SUBJECT: NuScale Power, LLC Supplemental Response to NRC Request for Additional Information No. 9466 (eRAI No. 9466) on the NuScale Topical Report, "Non-Loss of Coolant Accident Analysis Methodology," TR-0516-49416, Revision 1

NuScale Supplemental Response to NRC Request for Additional Information eRAI No. 9466

Response to Request for Additional Information Docket: PROJ0769

eRAI No.: 9466

Figure 7-1 [Example of decay heat comparisons](#)

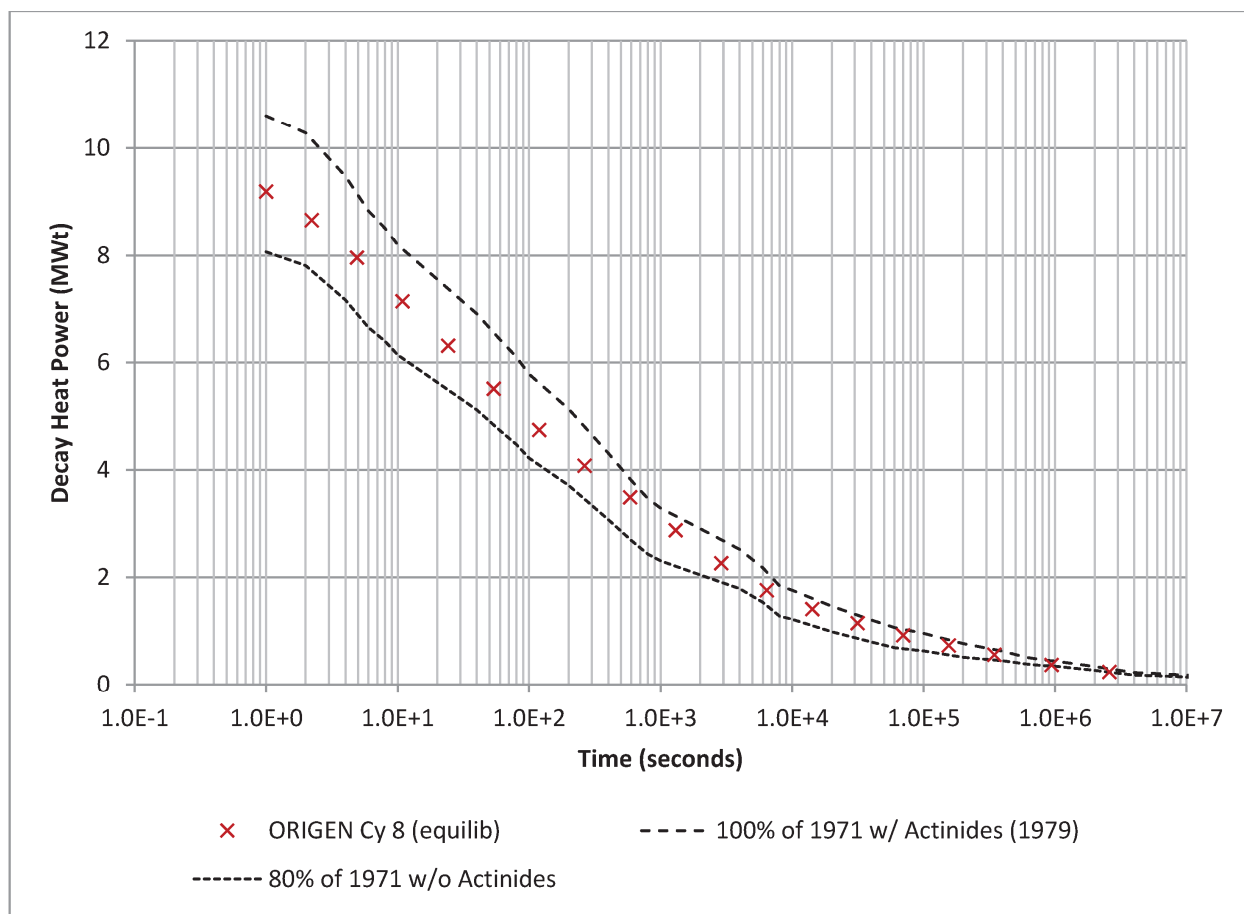
Provide the actual values of λ and η used and references for these parameters, and justify that the use of these values, the specified multipliers, and inclusion (or lack thereof) of actinides in combination with the 1973 decay heat model leads to a conservative result for decay heat contribution for all event types. Update TR-0516-49416-P and any other affected documentation as appropriate.

A best estimate decay heat curve was generated using the ORIGEN code for a generic equilibrium cycle. A sample figure which includes the minimum and maximum decay heat curves bounding the best estimate curve was added to the topical report Non-Loss of Coolant Accident Analysis Methodology, TR-0516-49416, as shown at the end of this response. The

The following decay heat contribution values are examples for the NPM. [Figure 7-1 provides an example of the decay heat as a function of time for an equilibrium cycle.](#) A review of the applicable core physics parameters is performed each cycle to confirm the bounding nature of the values utilized for the non-LOCA transient analyses.

- Low = use multiplier of 0.8 while excluding the actinide contribution
- High = use multiplier of 1.0 while including the actinide contribution
